MID-WESTERN REGIONAL COUNCIL
PO Box 156, MUDGEE NSW 2850
86 Market Street, Mudgee | 109 Herbert Street, Gulgong | 77 Louee Street, Rylstone
T 1300 765 002 or 02 6378 2850 | F 02 6378 2815
E council@midwestern.nsw.gov.au

8 November 2023

**SUBJECT: Advice on Environmental Impact Statement Central-West Orana REZ
Transmission (SSI-48323210)**

FIGURE 1: KOALA SIGHTINGS WITHIN AREAS OF DISTURBANCE.

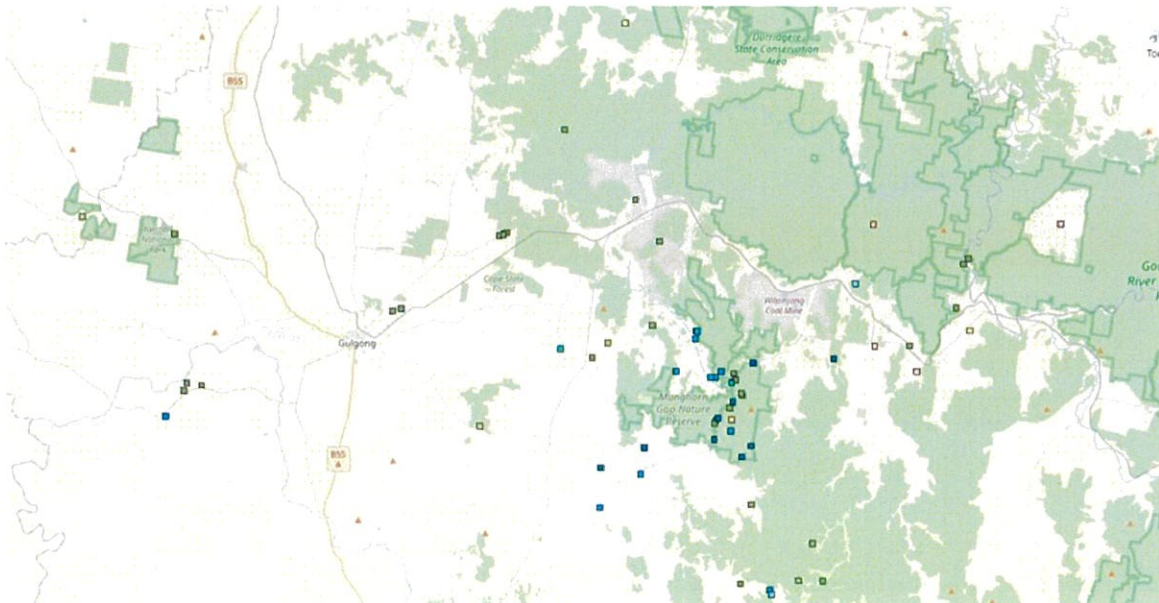
Council requests that the EIS report reflects further investigation into the presence of Koalas (*Phascolarctos cinereus*) and core koala habitat within the impacted area. As per the Koala Habitat Protection Guideline (2019), native vegetation within 5 km of a koala sighting is considered core koala habitat.

As indicated in the images from Bionet Atlas below there have been Koala sightings as recently as 2023, within the line of disturbance, that have not been considered within the report.

FIGURE 3: LOCATIONS OF PINE DONKEY ORCHIDS WITHIN THE AREA OF DISTURBANCE FOR THIS PROJECT

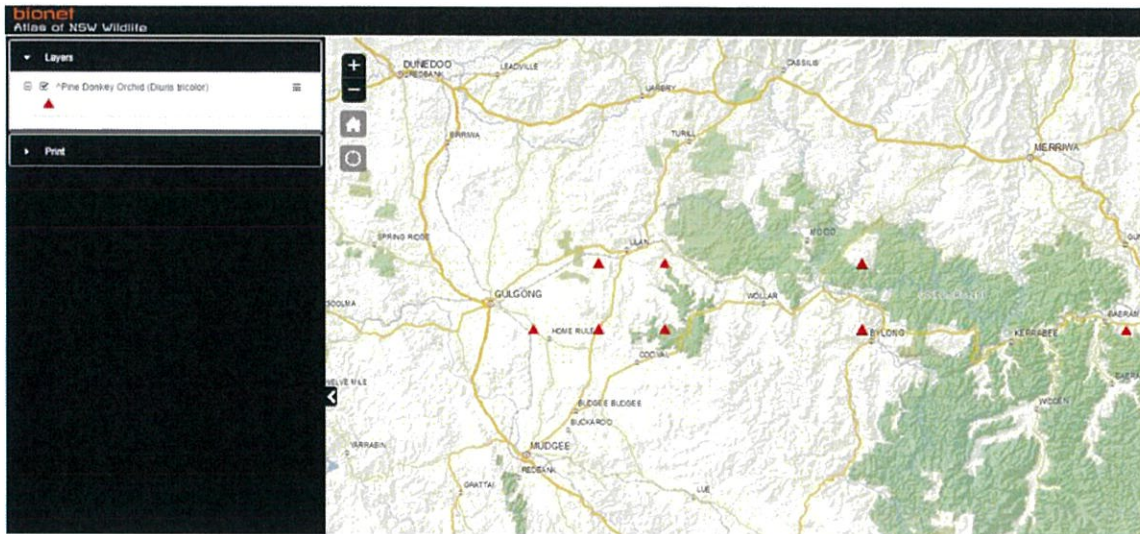
Pine Donkey Orchid (*Diuris tricolor*) is not addressed within the report. Council requests appropriate surveillance for this plant within its growing season is undertaken. As shown in the image below, they were found within the disturbance area.

Figure 4-8 Monitoring locations at Ulan Coal Mine

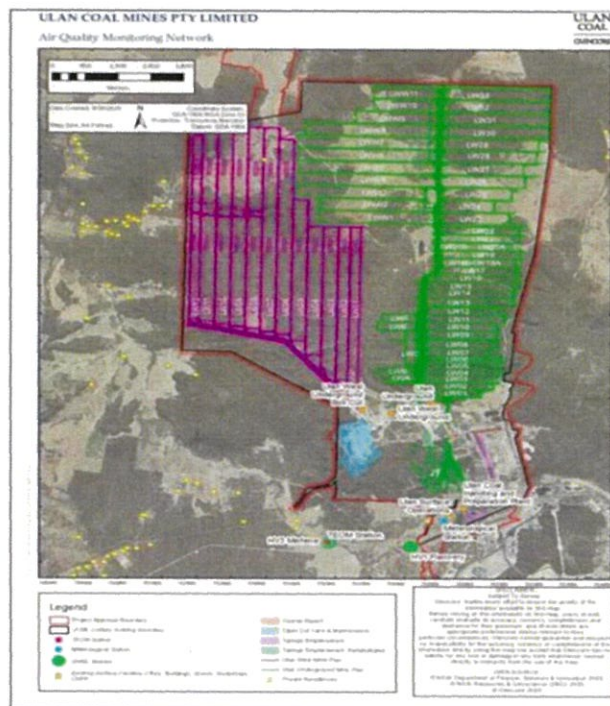
Council requests an air quality monitoring network similar to Ulan Coal Mines as depicted on page 47 Technical Paper 18, Figure 4-8 (extract below). Council understands that mitigation measures noted in Technical Paper 18 reduce emissions to low or negligible, however for baseline and future air quality reporting, Council requests air quality monitoring stations installed specifically at the accommodation camp, batching plant, unsealed roads, sensitive receivers within 350 m (539 and 543) and sporadically along construction routes. Council requests stations be erected immediately to establish a baseline for the project. The stations should be monitored 3 x day during construction and 1 x day during operation.
